**EPA Superfund  
Record of Decision Amendment:**

**TRACY DEFENSE DEPOT (USARMY)  
EPA ID: CA4971520834  
OU 01  
TRACY, CA  
06/21/2004**

**Re: Final Amendment to the Sitewide Comprehensive Record of Decision,  
Defense Distribution Depot San Joaquin (DDJC), Tracy Site, Tracy,  
California, December 2003**

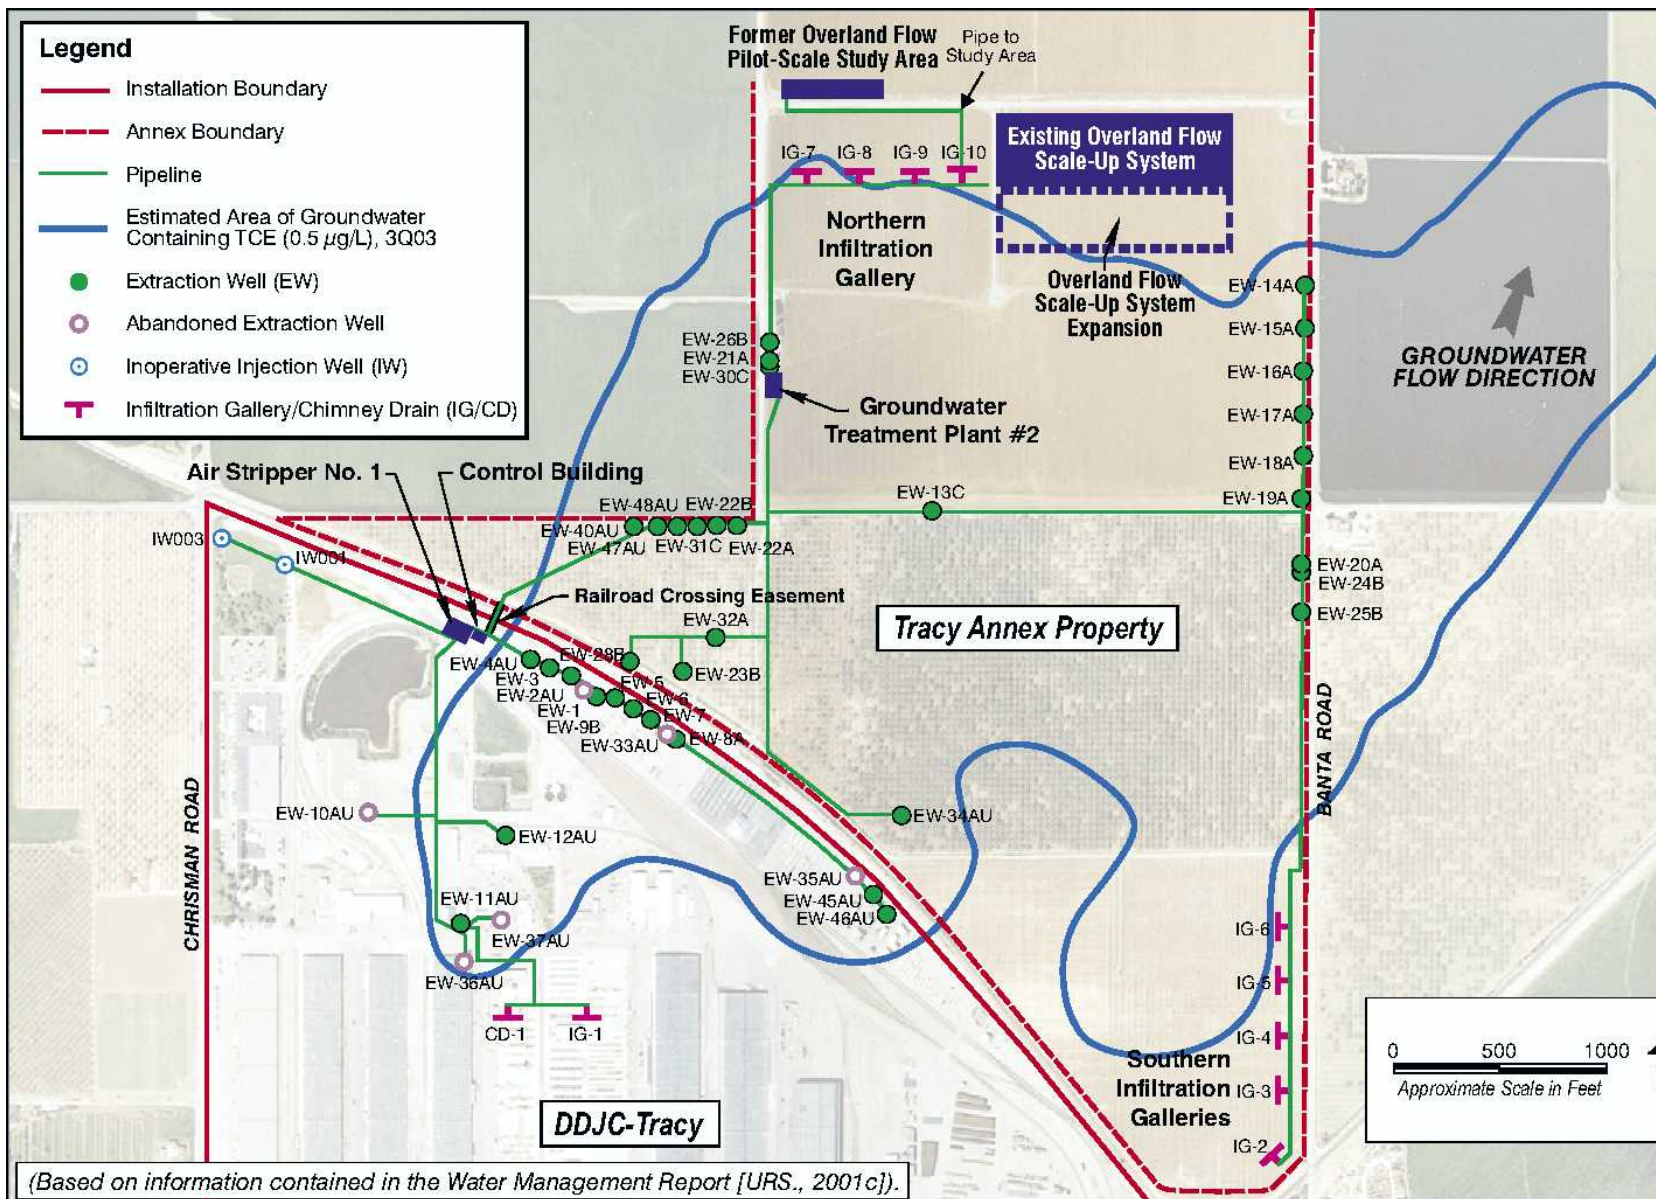
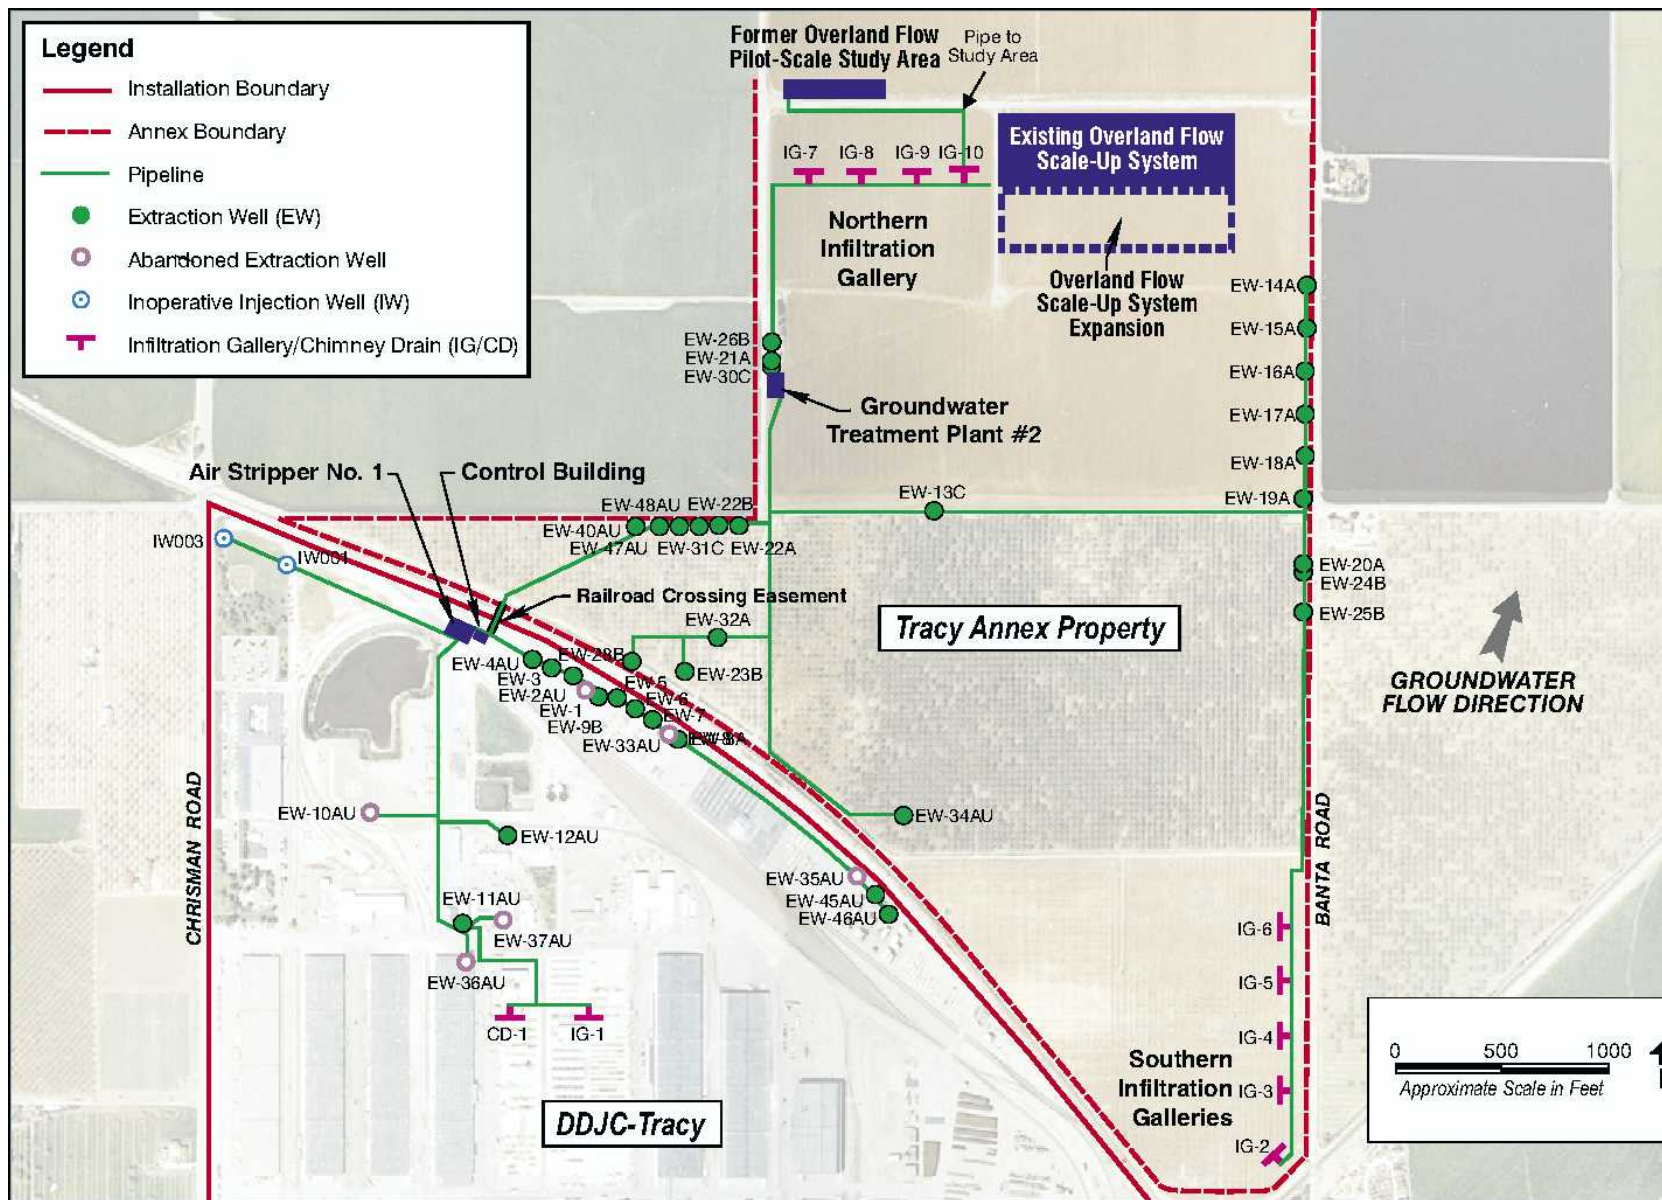
7.	Pages 3-3/3-9, Figures 3-1/3-2	On both figures there appears to be an extraction well (EW) represented by a green dot between CD-1 and IG-1. Please identify the EW in both figures. If it is not an EW, but rather a junction point showing where the line splits in two directions, then show this with another symbol that has not been defined in the legend.	(A) There is no extraction well between the CD-1 and the IG-1. The symbol will be removed for clarification.
		ACTION CODES A - ACCEPTED/CONCUR D - ACTION DEFERRED	W - WITHDRAWN N - NON-CONCUR VE - VE POTENTIAL/VEP ATTACHED
